Sandown Quarry Landfill Restoration  
Stubbers Green Road, Aldridge, Walsall  
Surface Water Management Plan  
Addendum

Report Ref. 07200/SWMP/R02

This addendum is to accompany the Surface Water Management Plan submitted with the planning application and is to provide additional information in response to comments.

Drg No.: 07200 - 010 Rev.:01

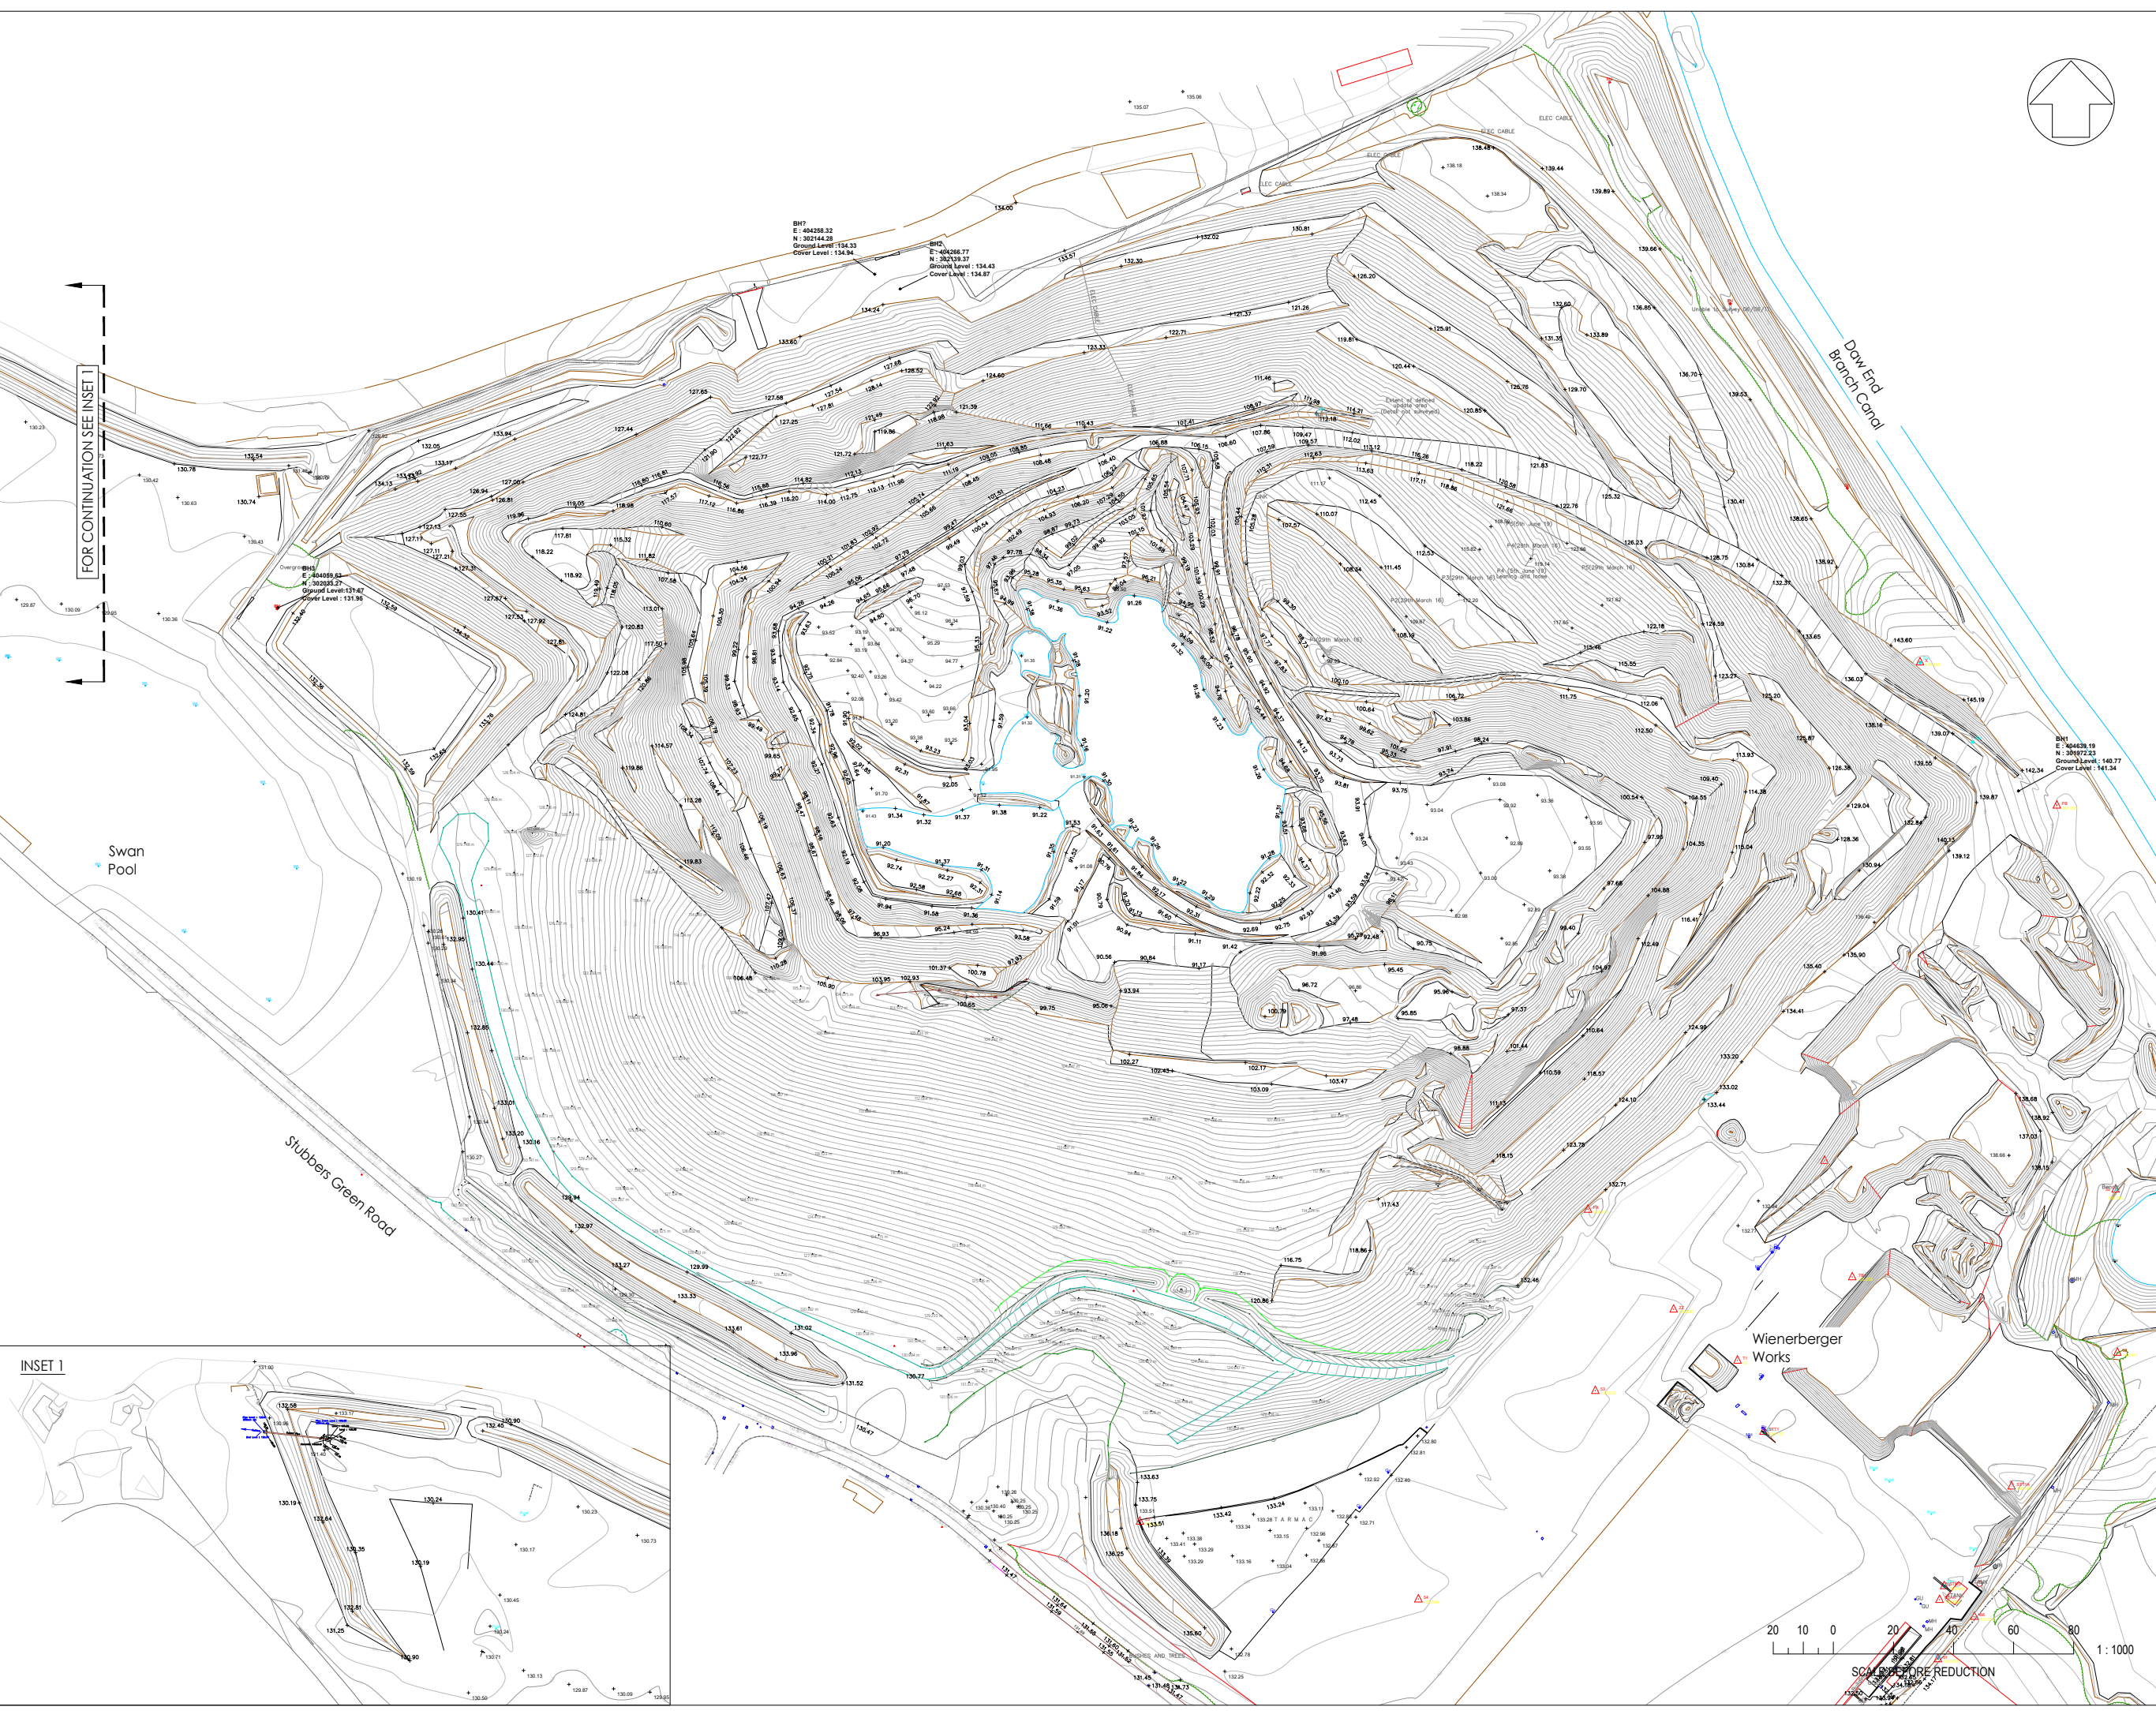
1. Booth Ventures topographic survey updated with detailed site outfall added August 2023

Status: Information	Drg No.: 07200 - 100	Rev.: 05
---------------------	----------------------	----------

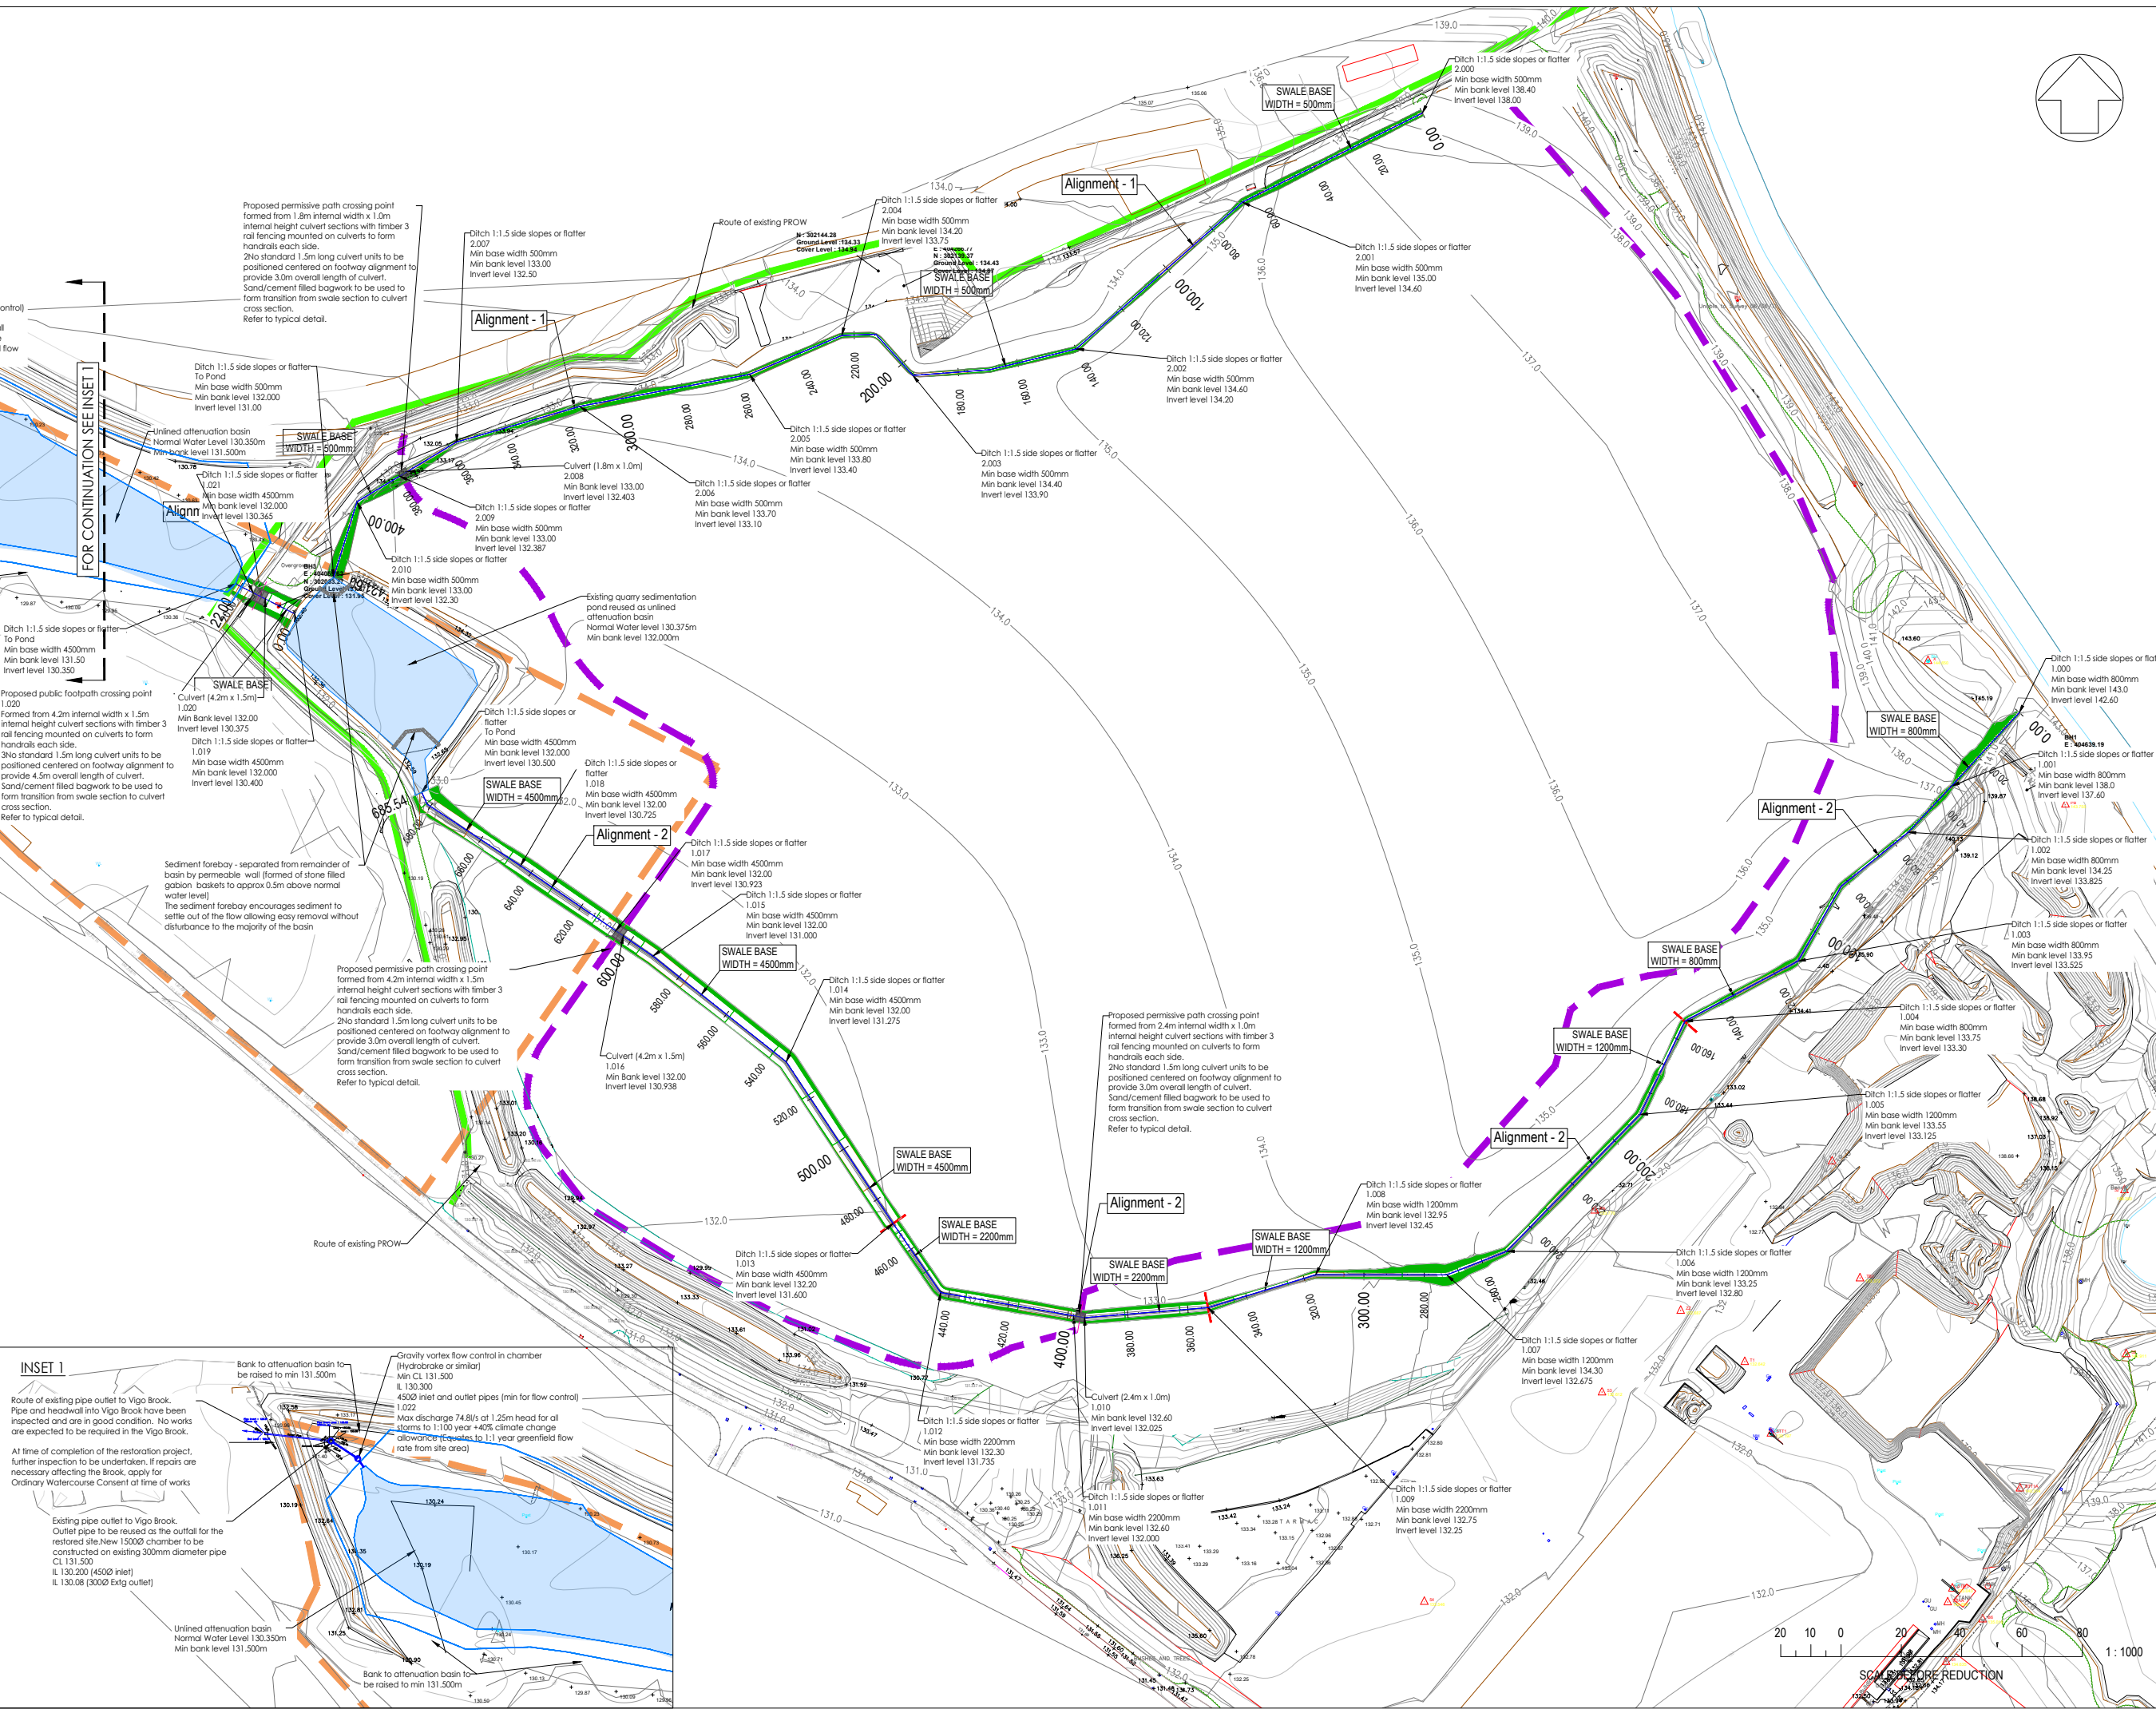
05 OUTFALL SURVEY ADDED & OUTFALL DETAIL UPDATED. MINOR DRAINAGE UPDATES PATHS AND SSSI SHOWN. PATH CROSSINGS AND OUTFALL NOTES ADDED

Attenuation Basin 2 outlet with Vortex Flow Control  
Scale NTS

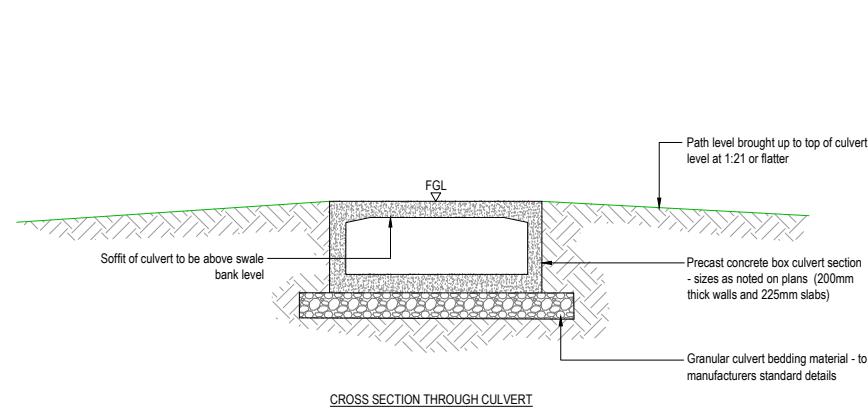
02 SURVEYED OUTFALL LEVELS ADDED	25.08.23	TG		
DETAIL UPDATED TO MATCH GA				
01 CULVERT DETAIL ADDED, OUTFALL DETAIL CLARIFIED	26.07.23	TG		
00 ISSUED FOR INFORMATION	04.08.22	JC TG		
Rev	Description	Date	Dwn	Ch'd
